Project	IEEE 802.16 Broadband Wireless Access Working Group < http://ieee802.org/16 >	
Title	BS to BS Time Synchronization Support, for OFDMA PHY mode	
Date Submitted	2004-09-01	
Source(s)	Geunhwi Lim, Yong Chang, Seung Joo Maeng, Hong Sung Chang, JungWon Kim, TaeWon Kim Samsung Electronics Co. Ltd.	geunhwi.lim@samsung.com
	David Ashkenazi	david.ashkenazi@intel.com
Re:		
Abstract	BS to BS Time Synchronization Support, for OFDMA PHY mode	
Purpose	Adoption of proposed changes into P802.16e /D4-2004	
Notice	This document has been prepared to assist IEEE 802.16. It is offered as a basis for discussion and is not binding on the contributing individual(s) or organization(s). The material in this document is subject to change in form and content after further study. The contributor(s) reserve(s) the right to add, amend or withdraw material contained herein.	
Release	The contributor grants a free, irrevocable license to the IEEE to incorporate material contained in this contribution, and any modifications thereof, in the creation of an IEEE Standards publication; to copyright in the IEEE's name any IEEE Standards publication even though it may include portions of this contribution; and at

Figure 1 Initial BS-BS Time Synchronization

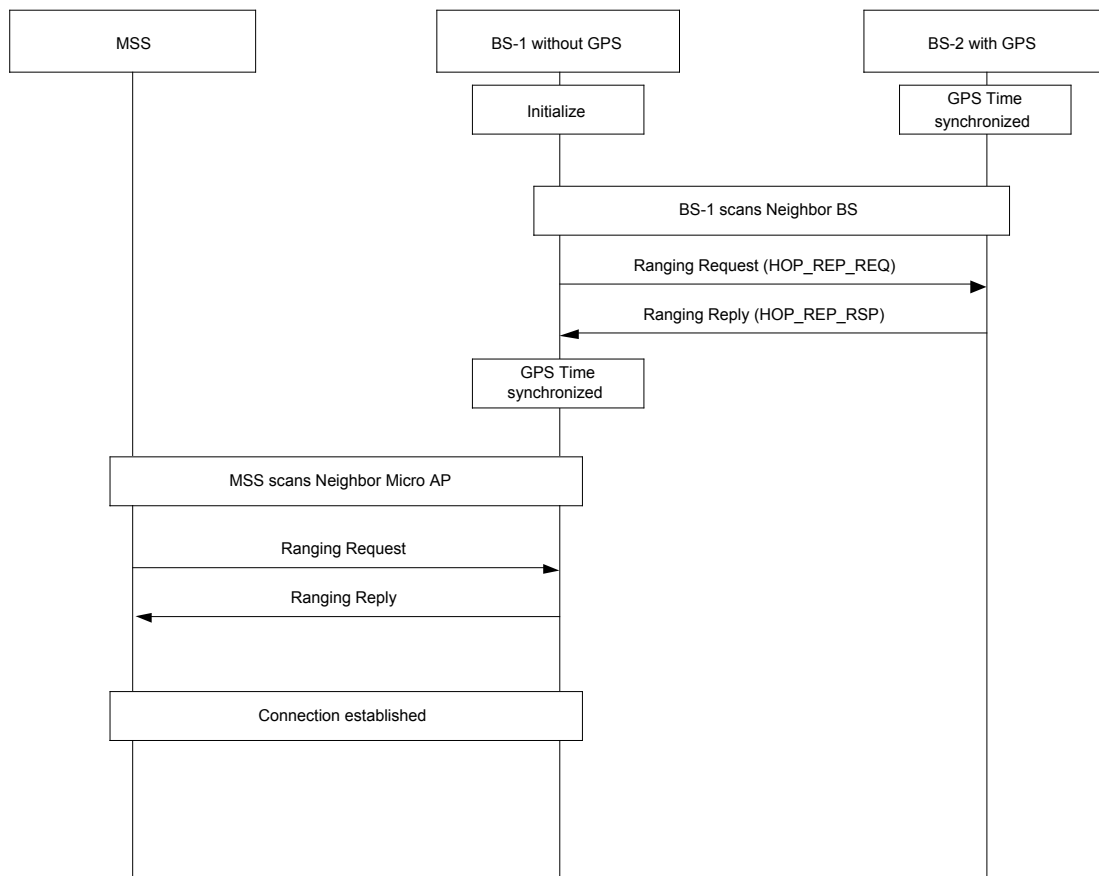
Because the BS should periodically calibrate the internal clock to maintain the time synchronization, BS should periodically perform ranging operation in MSS mode. During this period a BS which has only one RF interface can't serve MSS which is connected to the BS. -and all MSS attached to the BS should not access the BS during the period.
Hence, DCD message from a BS may include TLV to indicate the time and duration when the BS performs clock calibration.

6.3.18.1 BS-BS Time Synchronization Operation Scenario
